ADDENDUM NO. 1
March 4, 2024

FIRE STATION # 1
City of Marion
Marion, AR 72364

The following changes, clarifications, additions or deletions shall be made a part of the Contract Documents.

A6.1

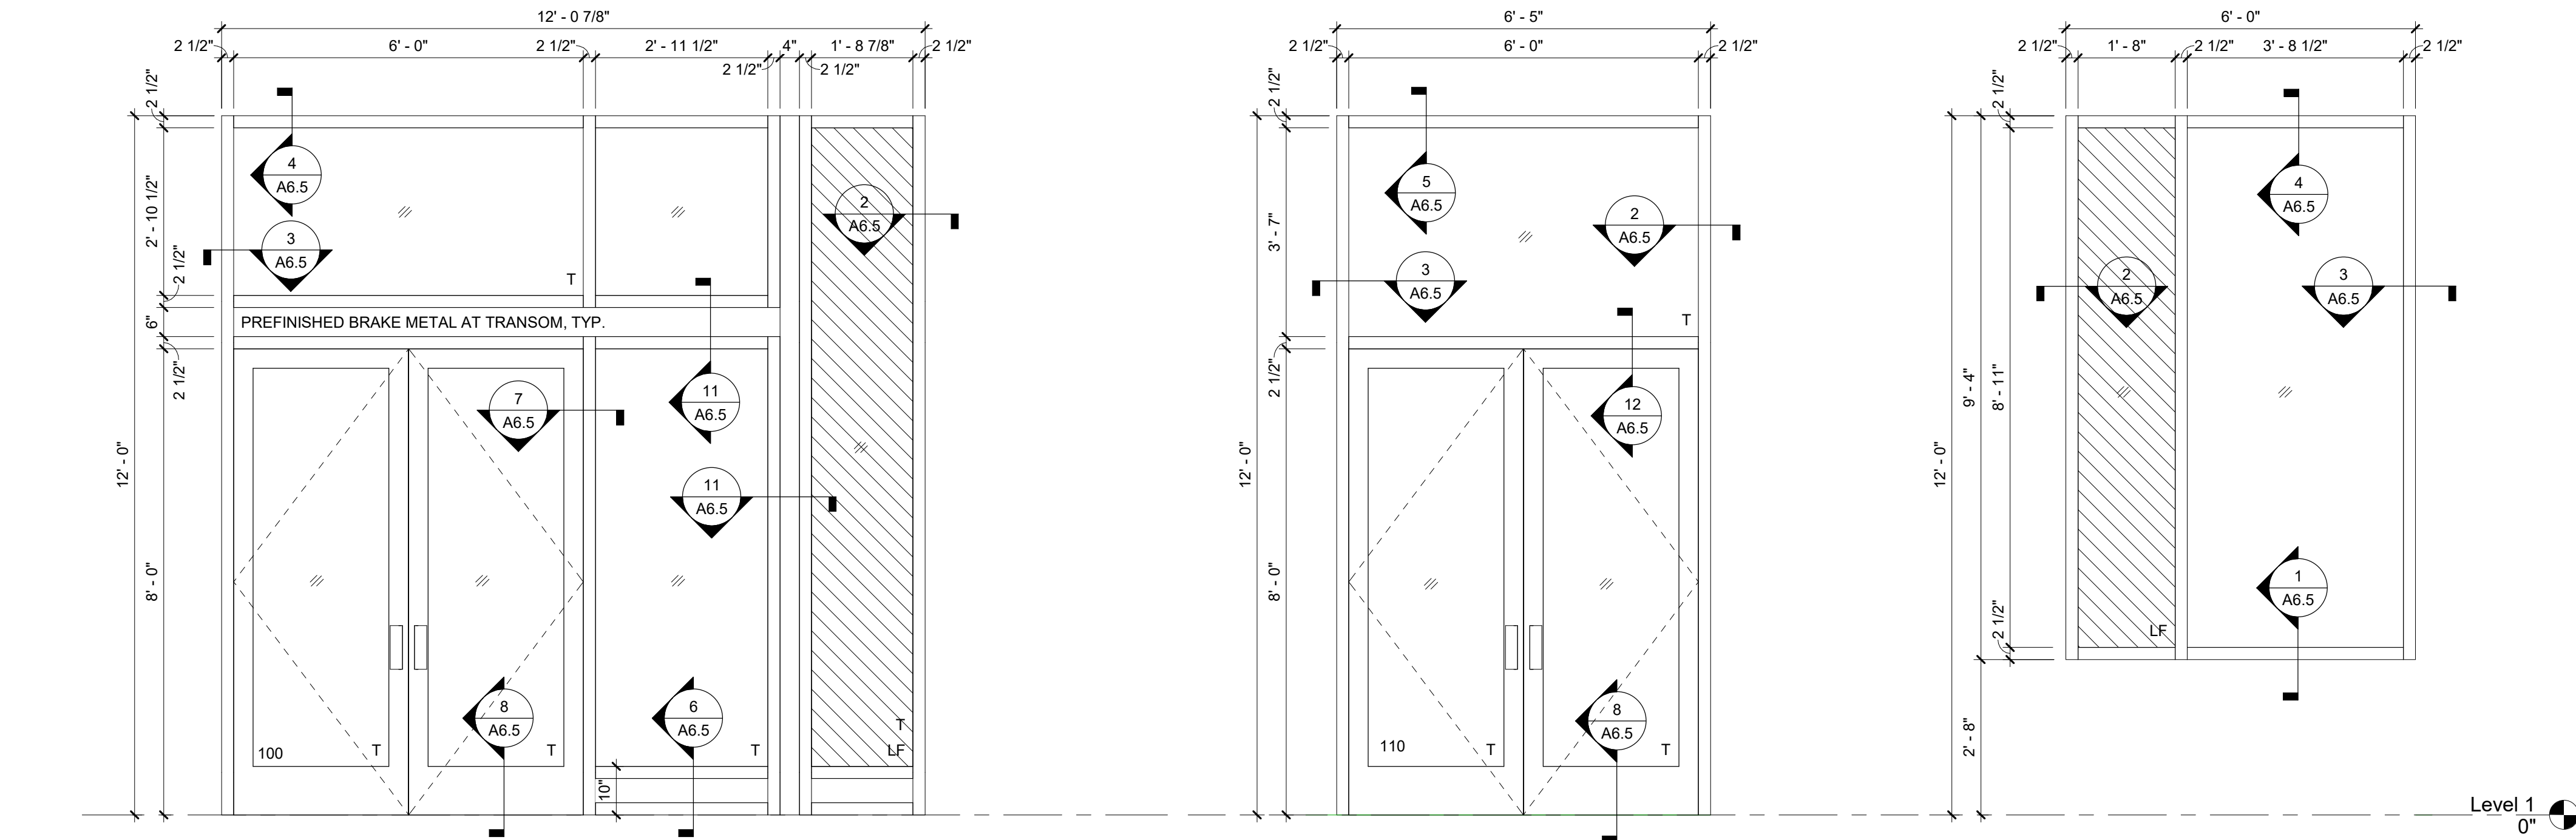
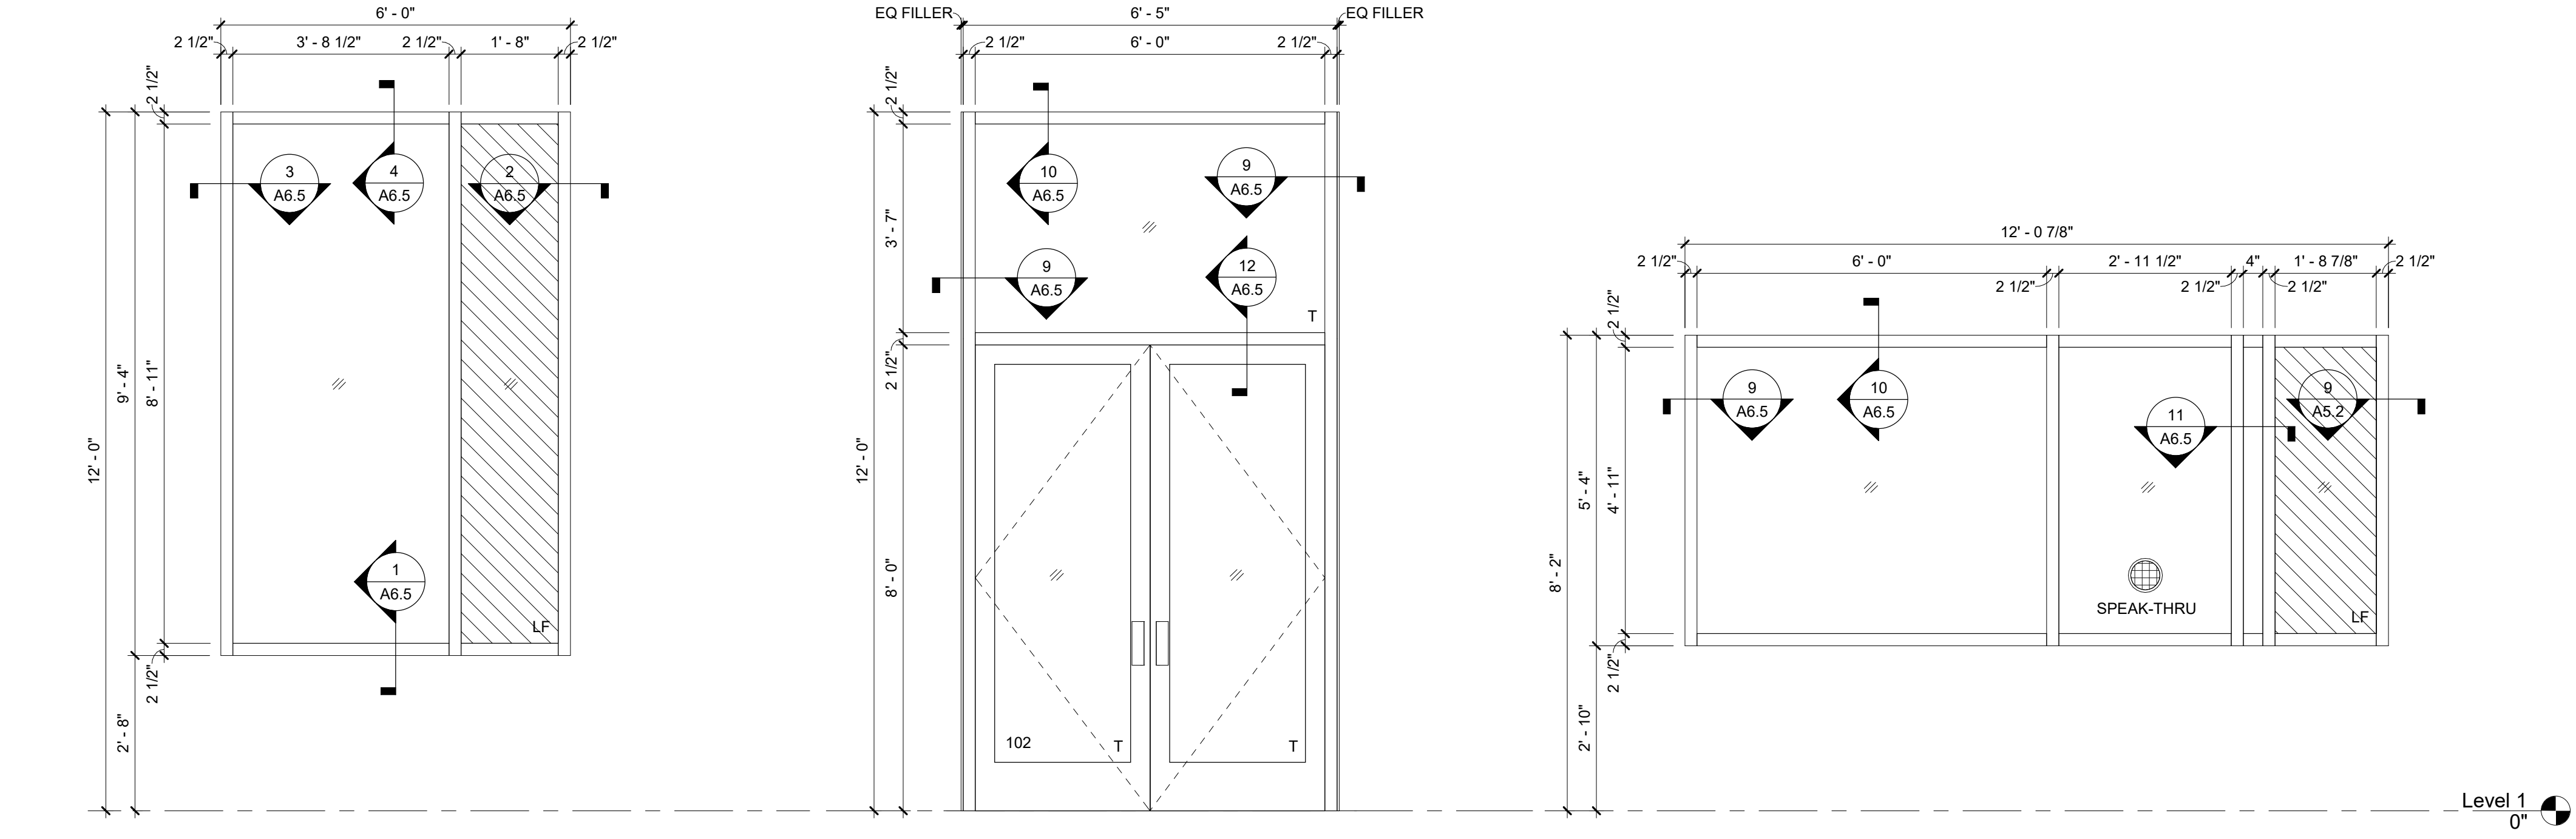
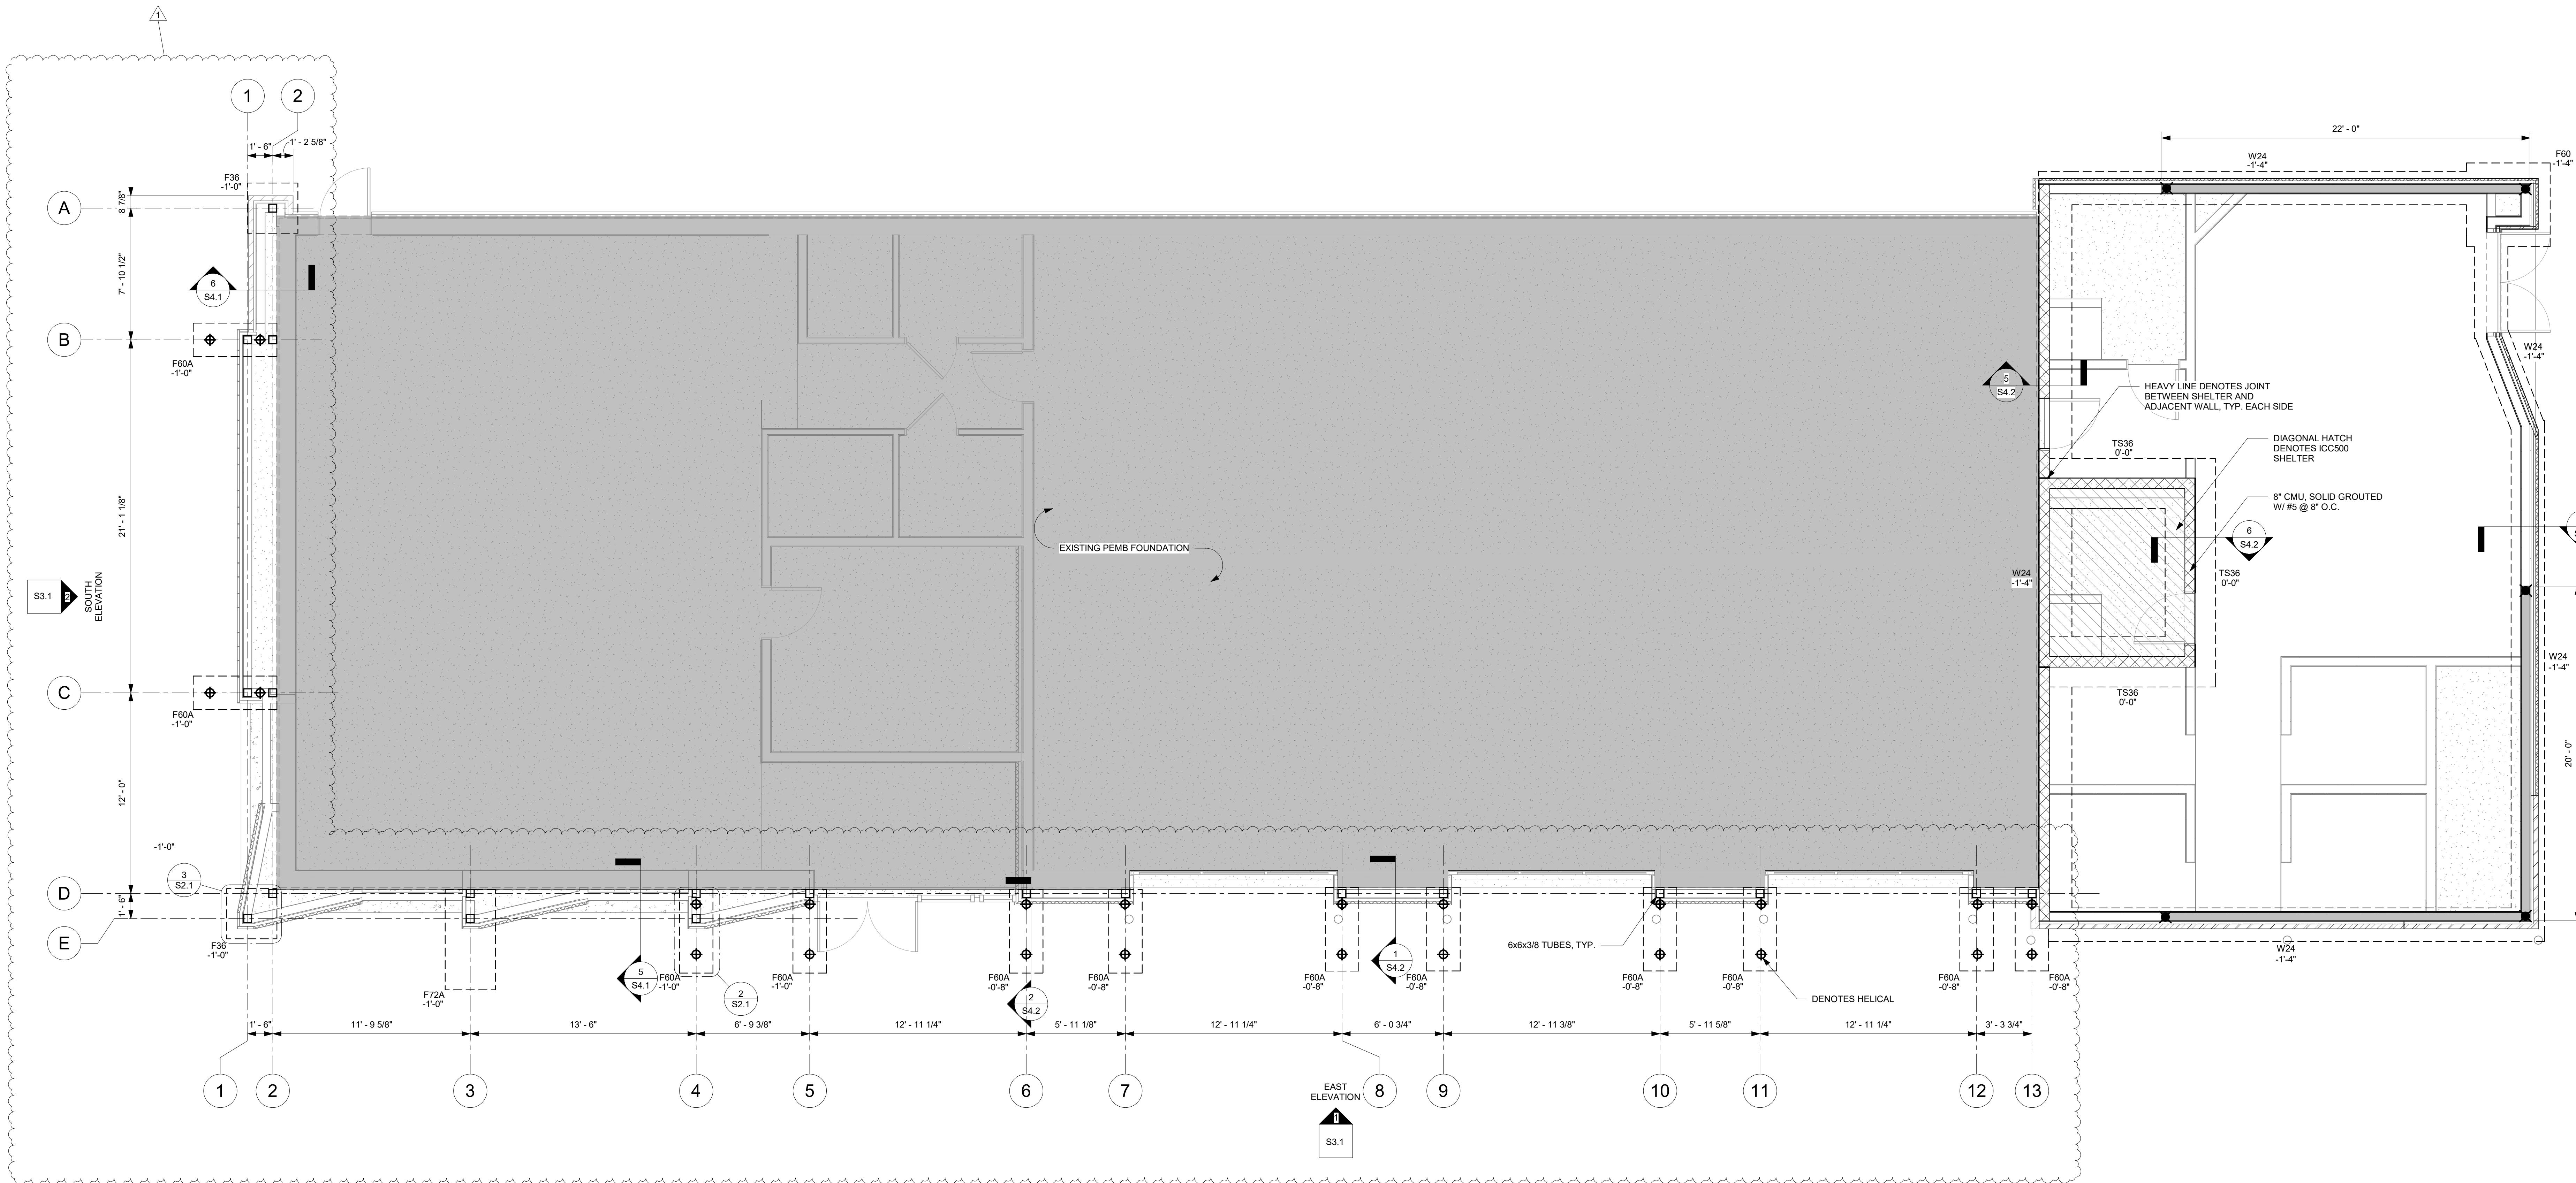
A6.1 Revised notes for Doors "EX1" and "EX2" and "EX3" for clarification.

Reference Drawings, sheet A6.1, Door Schedule, Door 102; Delete reference to door hardware listed in section 084100 aluminum Storefront, paragraph 2.06. Doors to receive hardware listed below:

2	Continuous Hinge	112XY 95"	628	IV
1	Exit Device	3547A-EO	US26D	VO
1	Exit Device	3547A-NL-OP x 388	US26D	VO
1	Rim Cylinder	20-057 ICX	626	SC
1	Interchangeable Core	23-030 MK	626	SC
2	Door Pull	8190EZHD-0	US32D316	IV
2	Closer	4111 SCUSH	AL	LC
2	Adapter Plate	4110-18	AL	LC
2	Cush Shoe Support	4110-30	AL	LC
2	Spacer	4110-61	689	LC
1	Gasketing	GASKETING BY FRAME MANUFACTURER	AL	VA0
